ADDENDUM NO. 1

Date: August 1, 2023
Project: **Primary Clarifier #1 Rehabilitation**
Job No.: 21600-06

EXHIBIT A

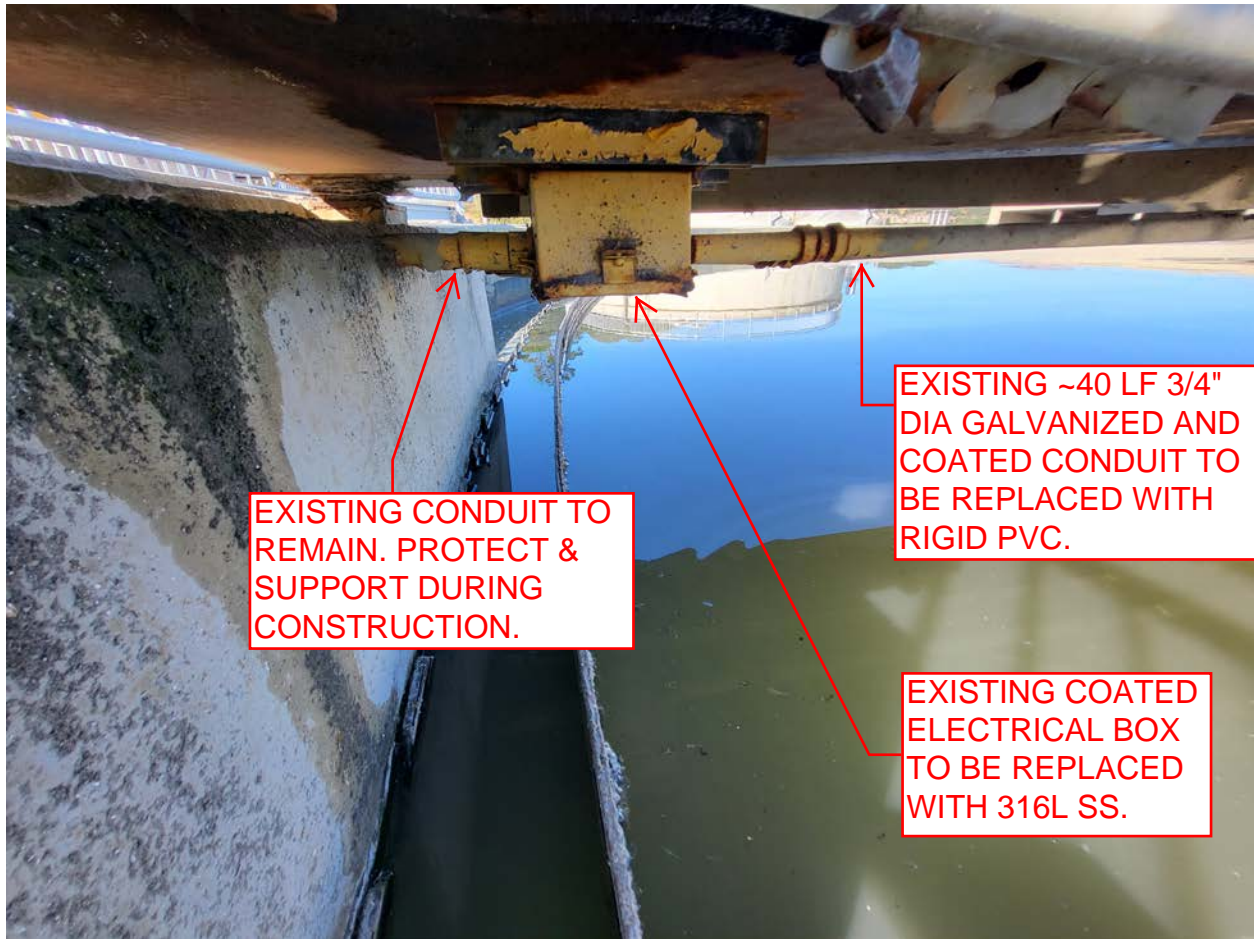
- iii. Approximately 40 LF of 3/4" diameter new rigid PVC conduit, cables, 316L SS fittings and boxes, etc., under the walkway for electrical power for the drive unit and lighting fixture. (See Exhibit A)

EXHIBIT B

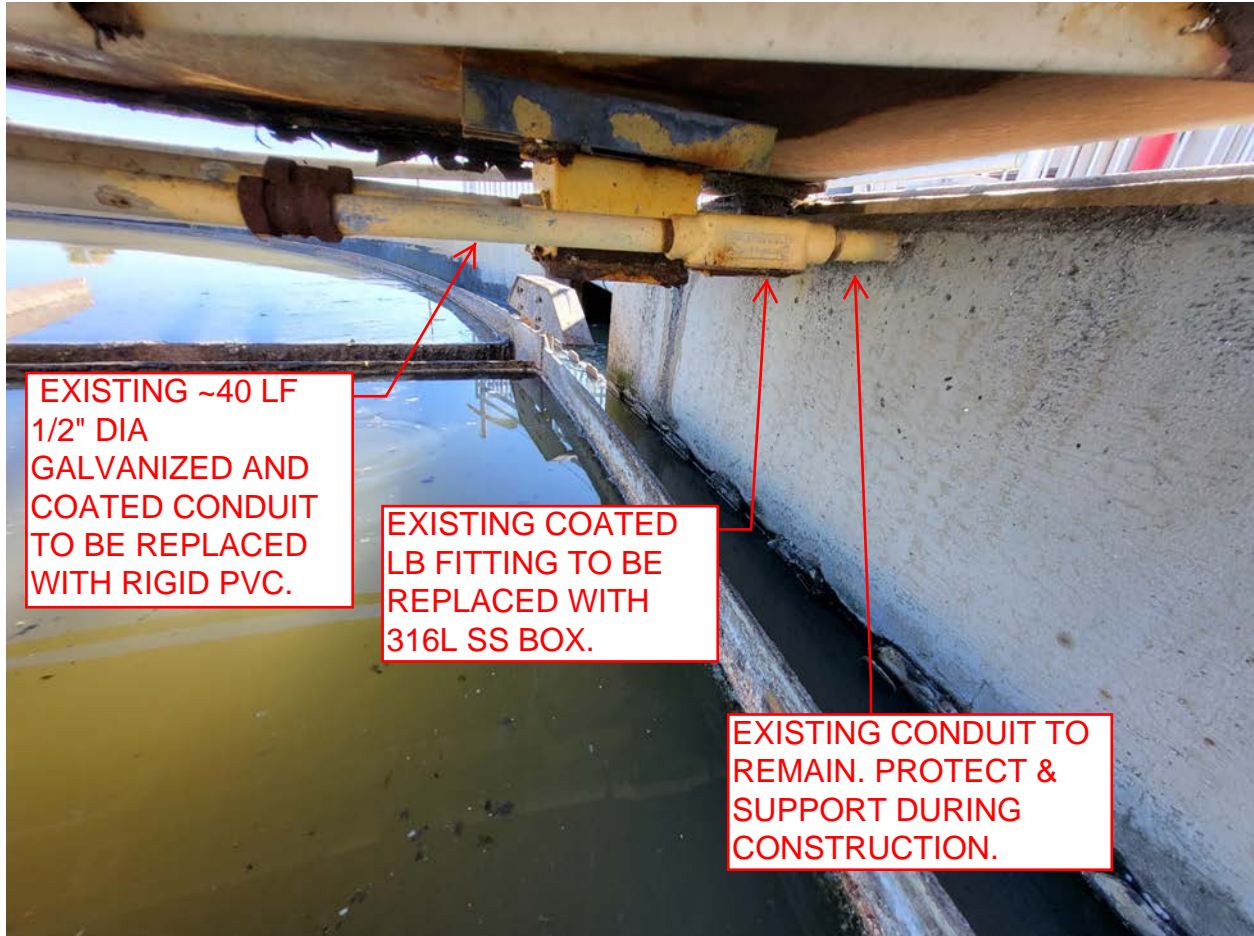
- iv. Approximately 40 LF of 1/2" diameter new rigid PVC conduit, cables, 316L SS fittings and boxes, etc., under the walkway for signal for the drive unit. (See Exhibit B)

EXISTING ~40 LF
1/2" DIA
GALVANIZED AND
COATED CONDUIT
TO BE REPLACED
WITH RIGID PVC.

EXISTING COATED
LB FITTING TO BE
REPLACED WITH
316L SS BOX.

EXISTING CONDUIT TO
REMAIN. PROTECT &
SUPPORT DURING
CONSTRUCTION.

EXHIBIT C

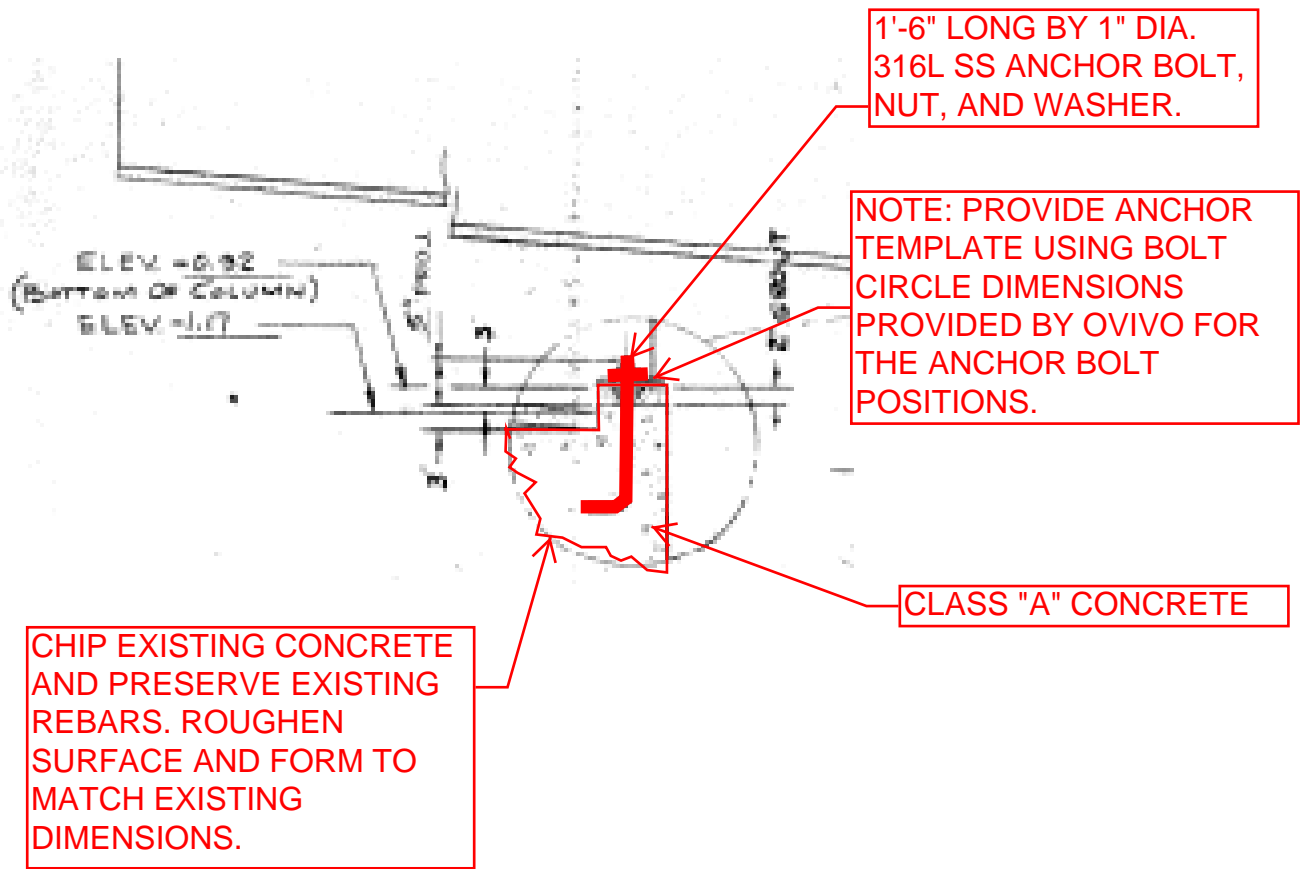
- v. Approximately 30 LF of 1/2" diameter new rigid PVC and flexible conduits, cables, 316L SS fittings and boxes, etc., at the side of the walkway for the existing ultrasonic transmitter. (See Exhibit C)

EXISTING ULTRASONIC TRANSMITTER TO BE REINSTALLED AFTER CONSTRUCTION.

EXISTING ~25 LF 1/2" DIA GALVANIZED AND COATED CONDUIT AND FITTINGS TO BE REPLACED WITH RIGID PVC.

EXISTING ~5 LF 1/2" DIA FLEXIBLE CONDUIT TO BE REPLACED WITH RIGID PVC.

EXISTING COATED JUNCTION BOX TO BE REPLACED WITH 316L SS.

EXISTING CONDUIT TO REMAIN. PROTECT & SUPPORT DURING CONSTRUCTION.
